FAIRFAX COUNTY

STAFF REPORT ADDENDUM

APPLICATION RZ/FDP 2000-MV-019

WASHINGTON HOMES
SILVERBROOK ROAD
MT. VERNON DISTRICT
PAMUNKEY COUNTY, VA

DETAILS

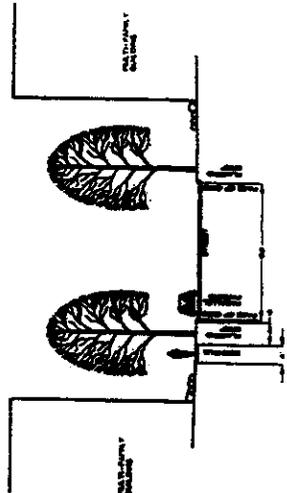
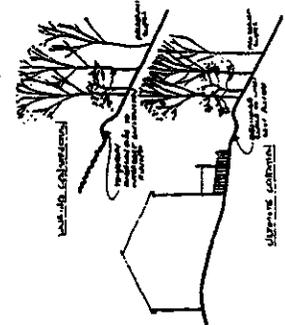
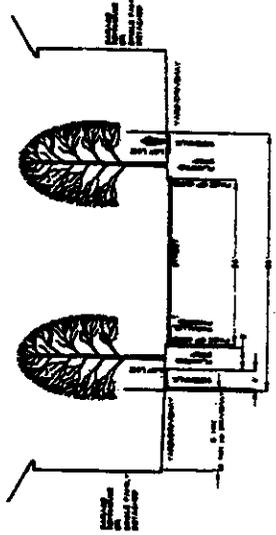
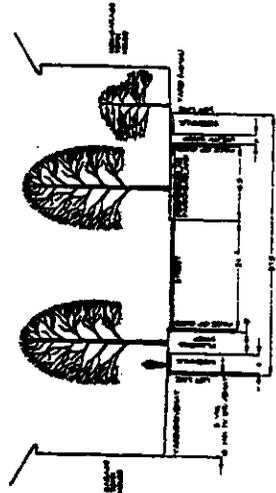
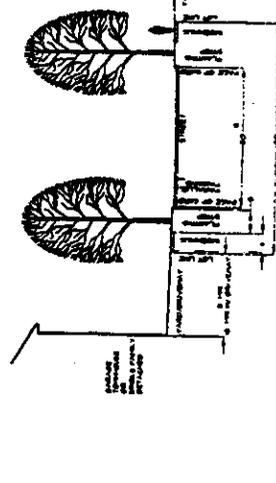
- An additional townhouse building with four (4) units has been added across from the proposed multi-family buildings.
- Sidewalks have been added to the travel aisle leading to the parking garage for the multi-family dwelling units. This change is also shown in section view on the Details included on Sheet 3.

TYPICAL LOT DETAILS

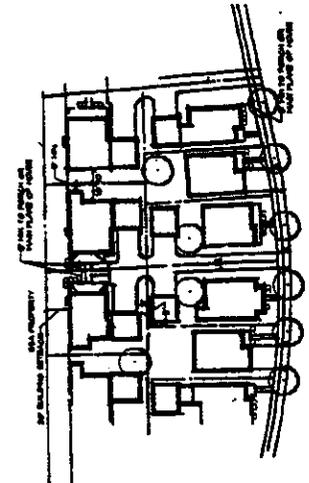
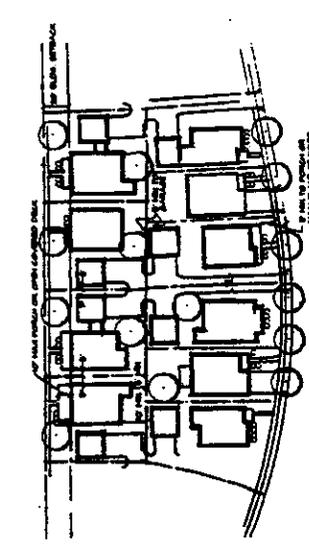
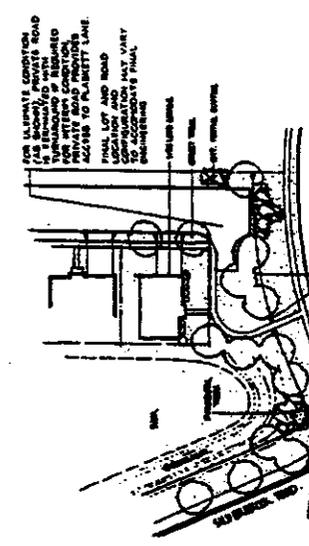
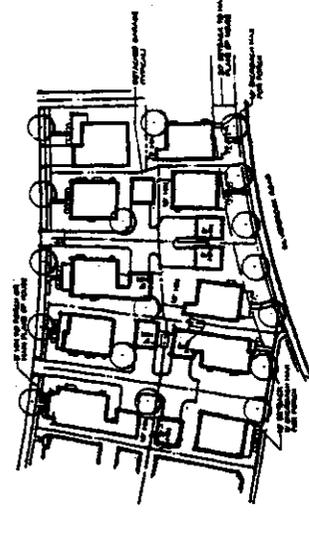
- The tennis court displaced by the additional townhouse building has been relocated to the area between the townhomes and Interstate 95.
- A detail for the area adjacent to Silverbrook Road has been added to the detailed single family detached lot layouts on Sheet 6. This detail shows the

dwelling units adjacent to Silverbrook Road fronting onto that street, with vehicular access to the lots provided from the internal streets. A similar feature is shown in a detail for the proposed units on Parcel 2 located north of the "Access Road."

- A second detail layout for the single family detached units along the northern boundary has been added. Option B shows a proposed layout with the units along that boundary fronting to the north, should that be feasible given the layout of any future development along that boundary.

1. Privacy fences shall be provided at the rear of the yards for all single family attached dwelling units located near the southern property boundary. This privacy fence shall be a minimum of six (6) feet in height.
2. The dwelling units located along Silverbrook Road shall not have direct access to that roadway. The access for those lots shall be in a manner similar to that shown on the typical lot details depicted on Sheet 6 of the FDP.
